Planning Commission Meeting Work Session
September 14, 2026 @ 6:30 PM
This meeting is recorded for public record.

West Chester Borough Planning Commission (PC) Meeting Minutes
Voting Meeting
August 10, 2026
6:30 PM

COVER SHEET FOR
TRBL WALNUT, LLC
615 & 617 S. WALNUT STREET
WEST CHESTER, PA 19382
WEST CHESTER BOROUGH • CHESTER COUNTY • PENNSYLVANIA

IMPROVEMENTS CONSTRUCTION PLAN FOR TRBL WALNUT, LLC 615 & 617 S. WALNUT STREET WEST CHESTER, PA 19382 WEST CHESTER BOROUGH • CHESTER COUNTY • PENNSYLVANIA

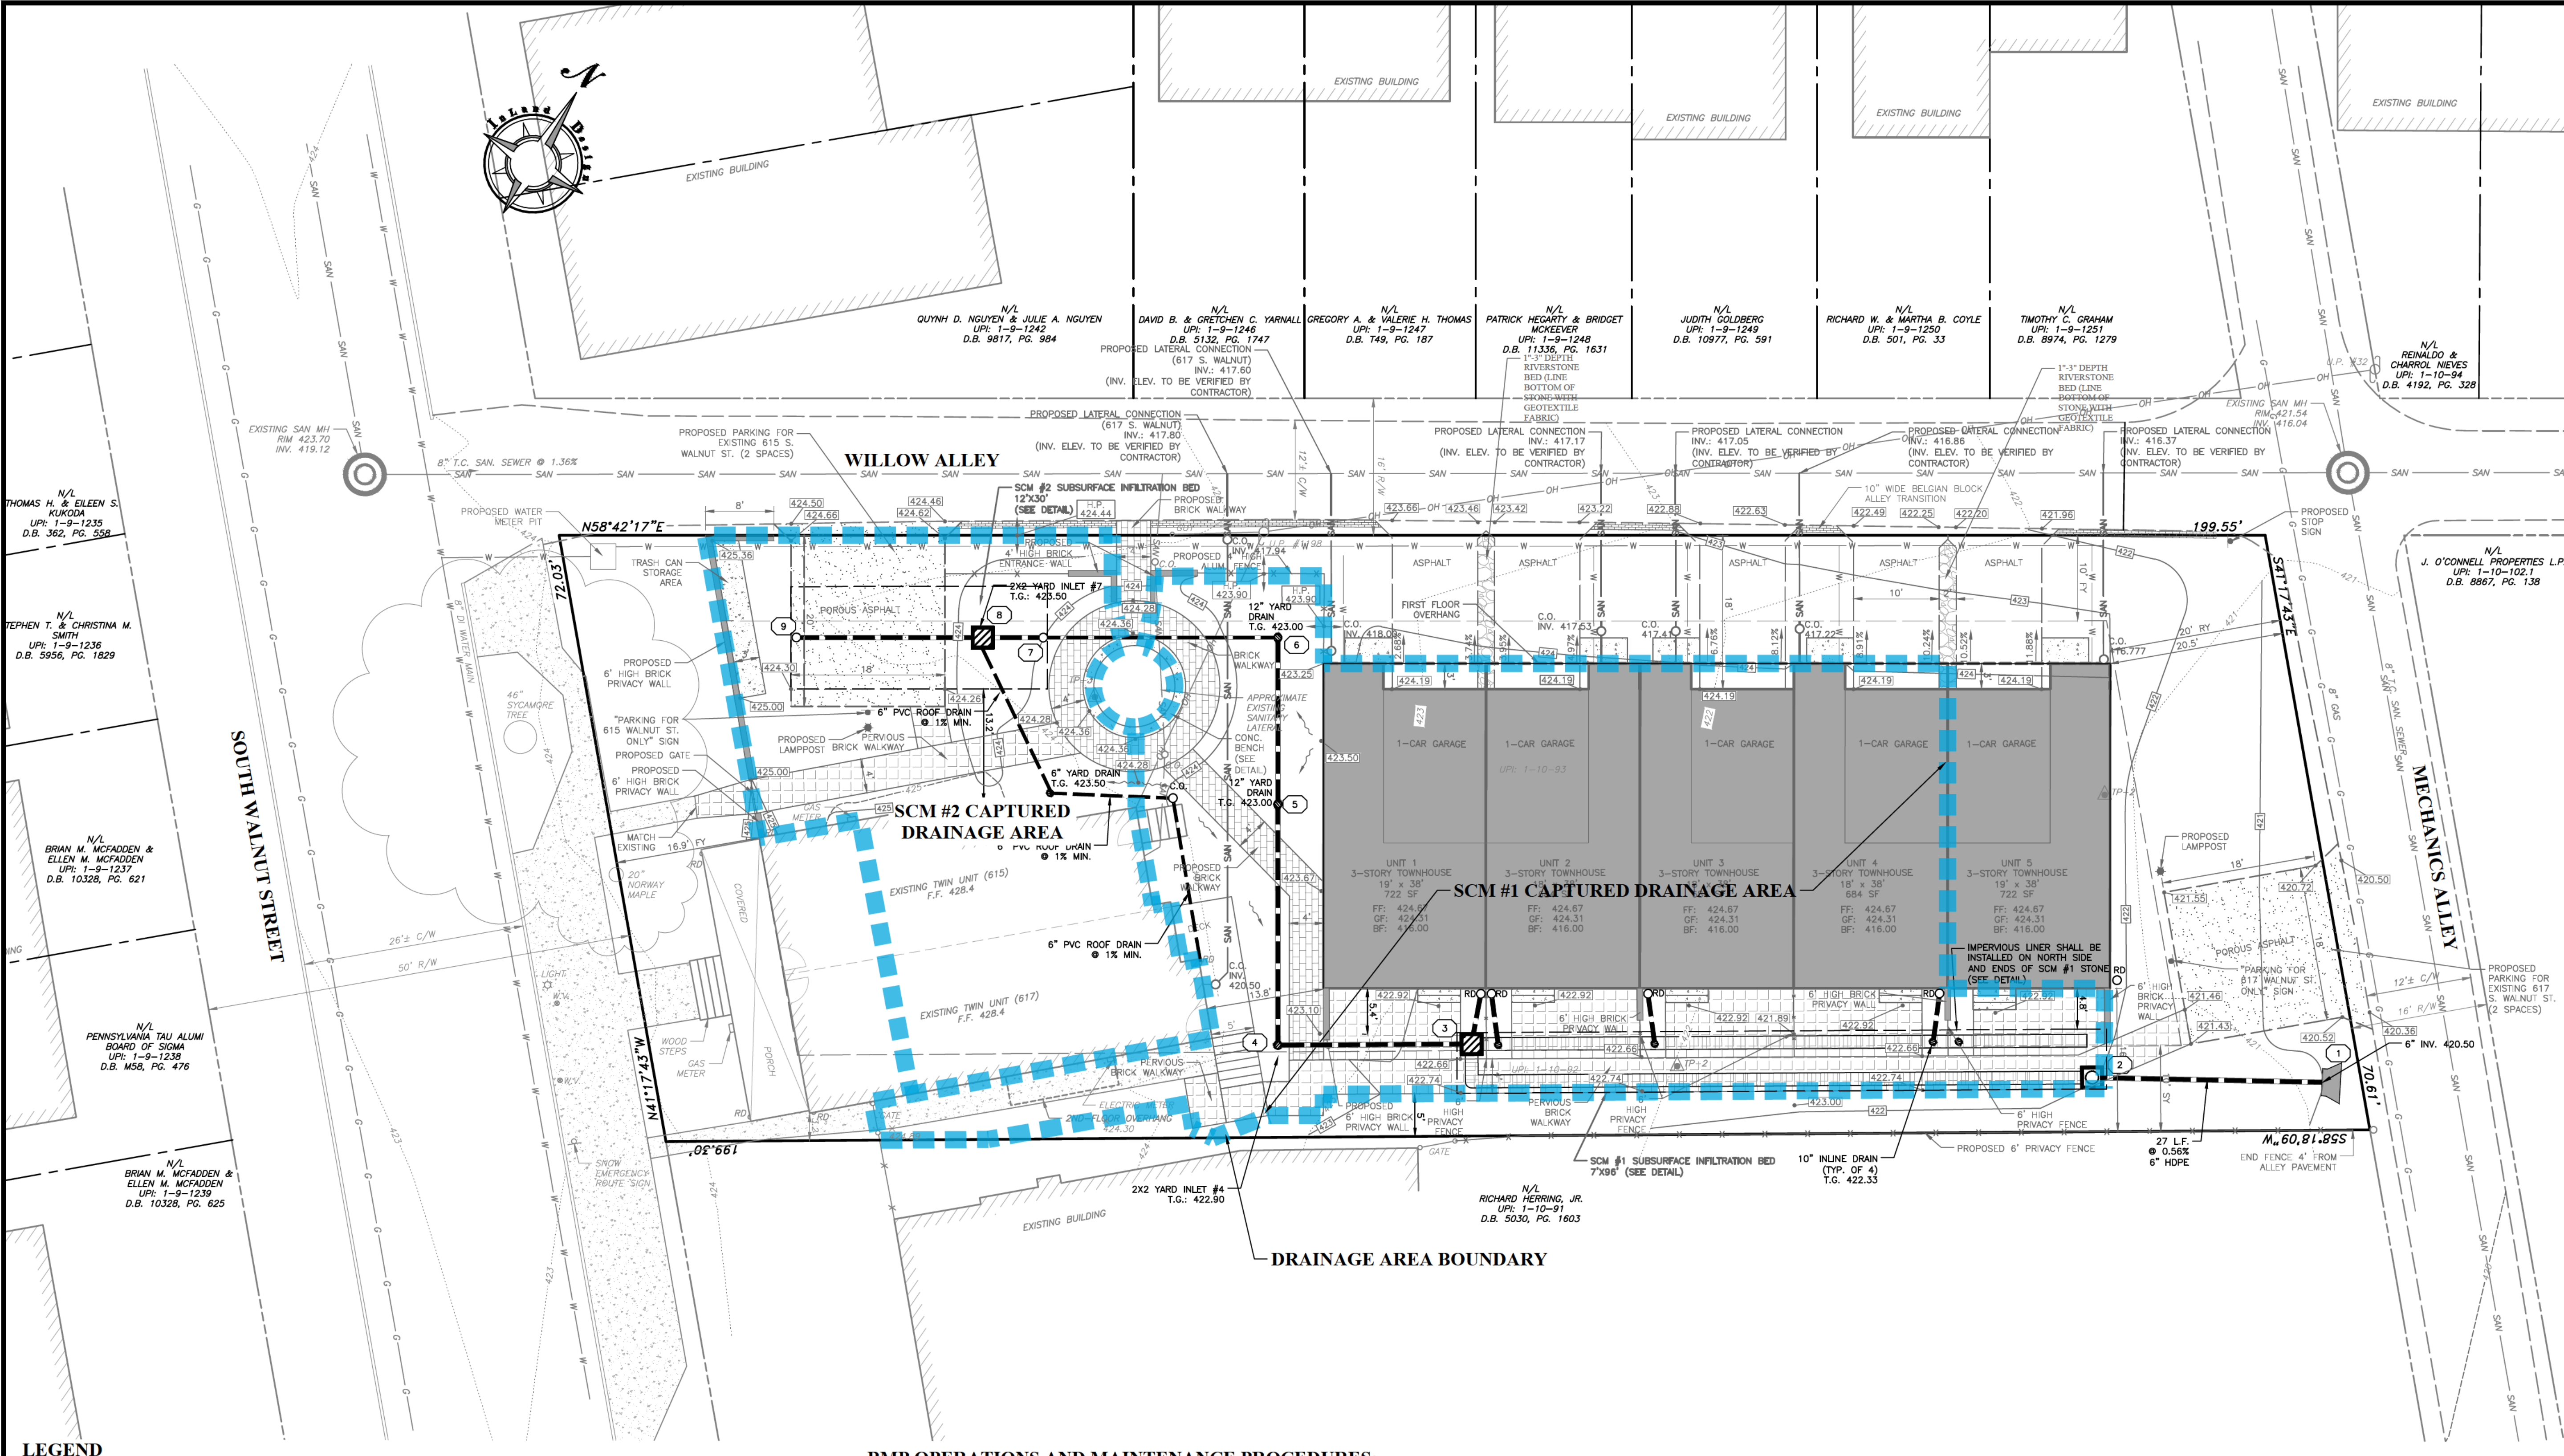
18. Additional spot grades should be added on Sheet 5 to clarify the topographic high points that will divide the drainage areas for SCM #1 & #2, so that the contractor can construct them accordingly. Additionally, the post-development drainage area plan identifies an existing undisturbed area is to be collected to SCM #1, but the topography does not appear to indicate that this area would be collected as intended. Additional contours and spot grades shall be added as needed to ensure that the intended area will drain to SCM #1. (§94-402.B(18)(b))

18. Additional spot grades should be added on Sheet 5 to clarify the topographic high points that will divide the drainage areas for SCM #1 & #2, so that the contractor can construct them accordingly. Additionally, the post-development drainage area plan identifies an existing undisturbed area is to be collected to SCM #1, but the topography does not appear to indicate that this area would be collected as intended. Additional contours and spot grades shall be added as needed to ensure that the intended area will drain to SCM #1. (§94-402.B(18)(b))

PCSM DETAILS 'B' FOR
TRBL WALNUT, LLC
615 & 617 S. WALNUT STREET
WEST CHESTER, PA 19382
WEST CHESTER BOROUGH • CHESTER COUNTY • PENNSYLVANIA

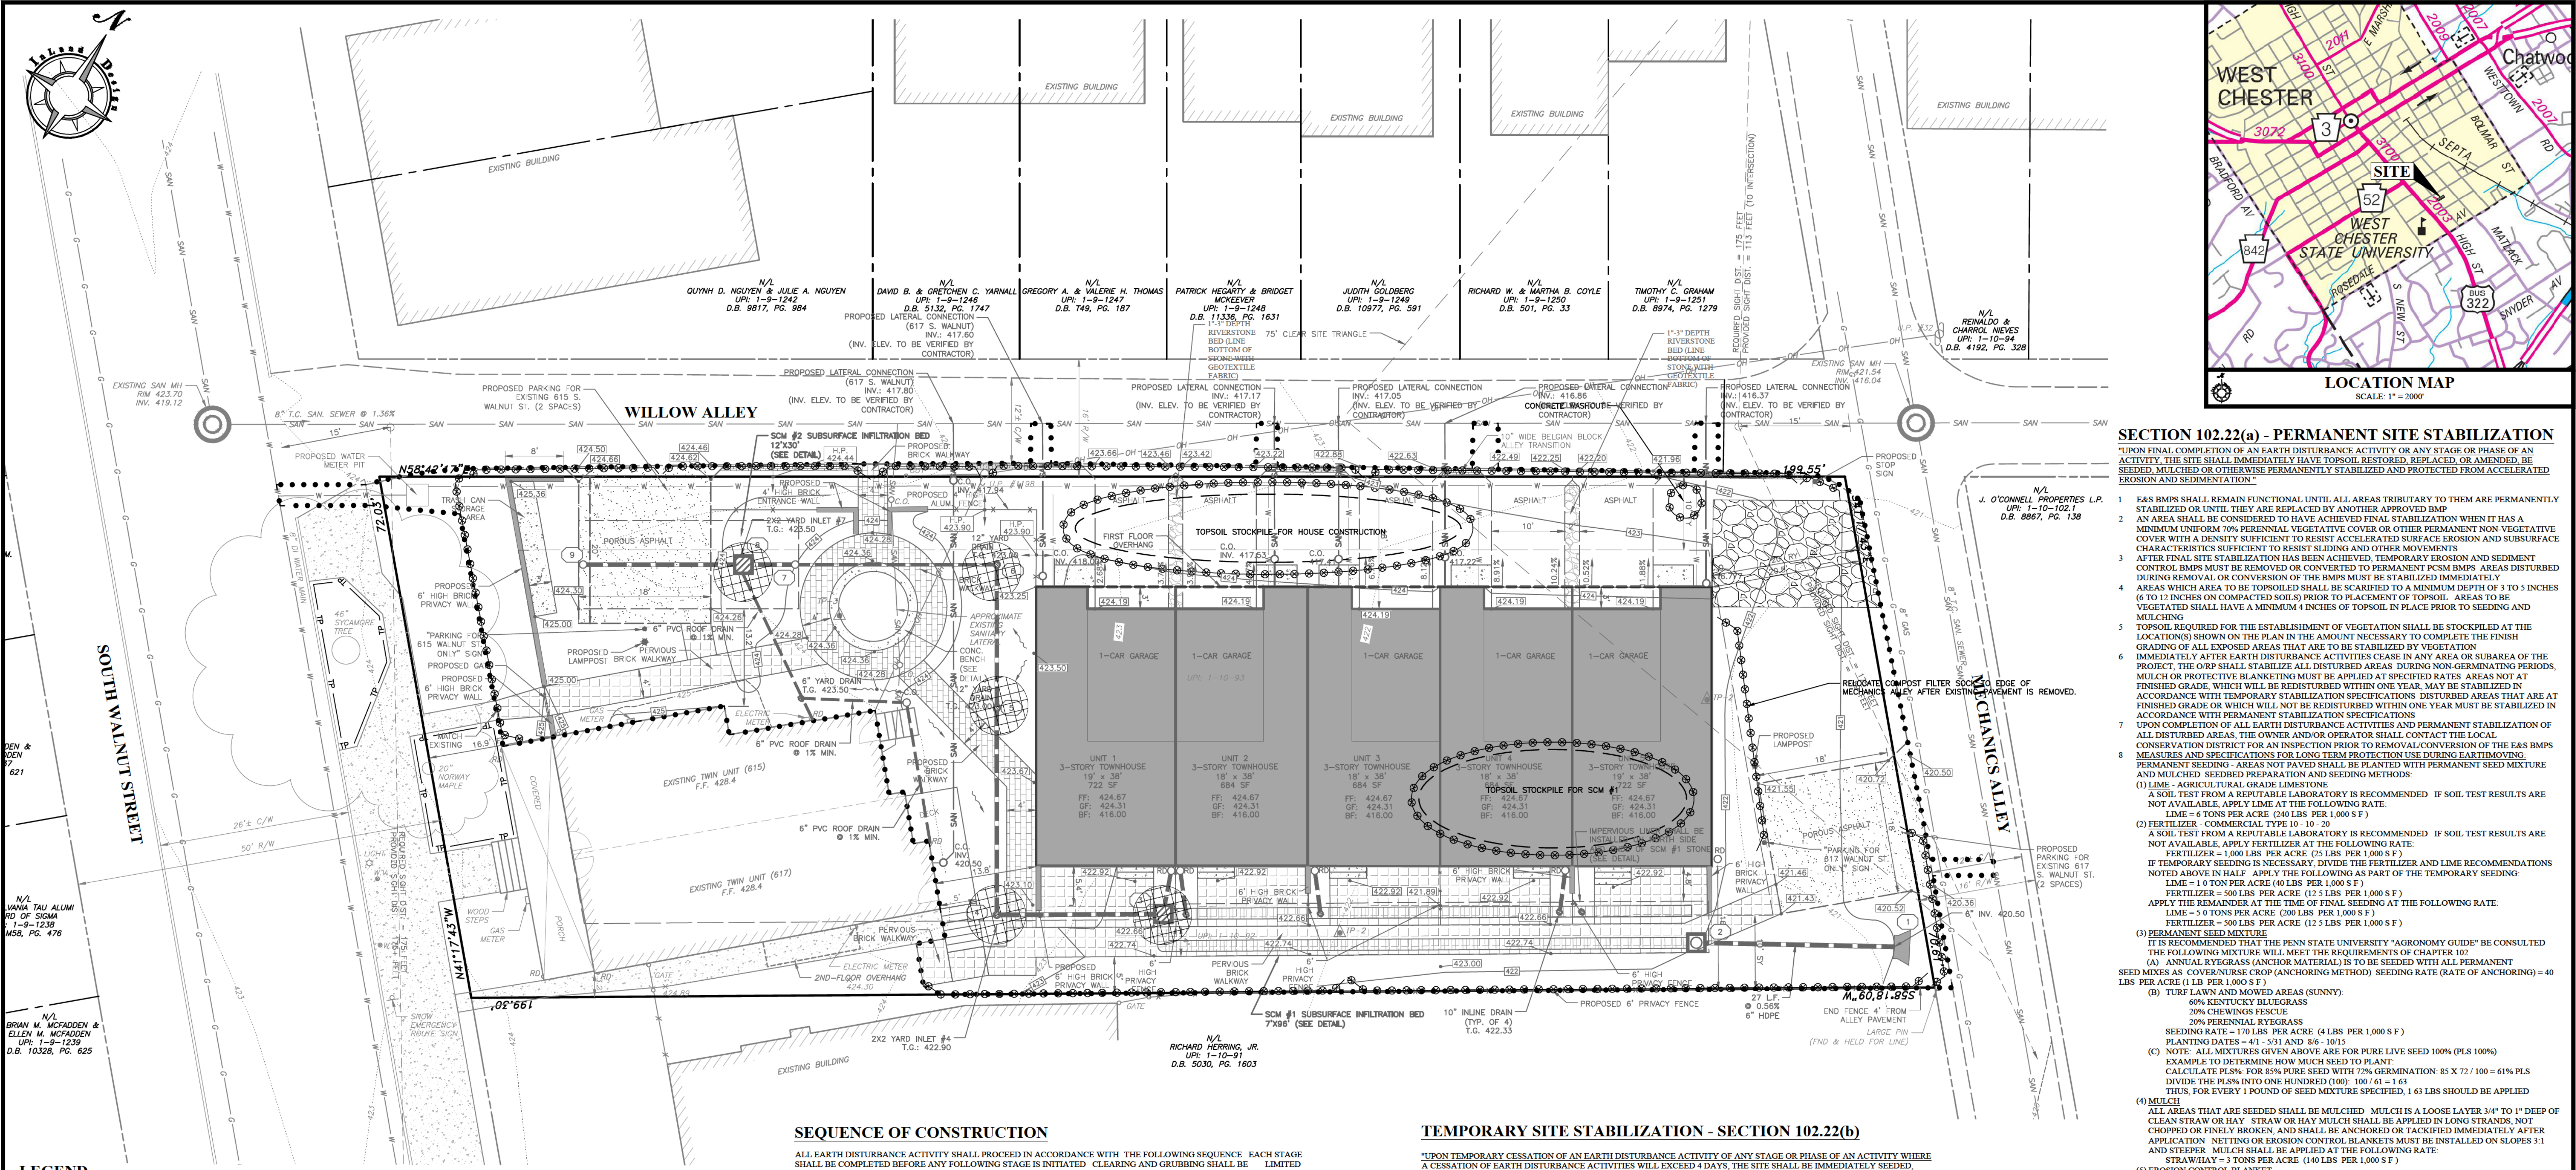
21. The structure material for the lawn inlet should be specified in the detail on Sheet 8.

Resolved. The drainage structure material has been labeled as concrete in the detail (Sheet 8).
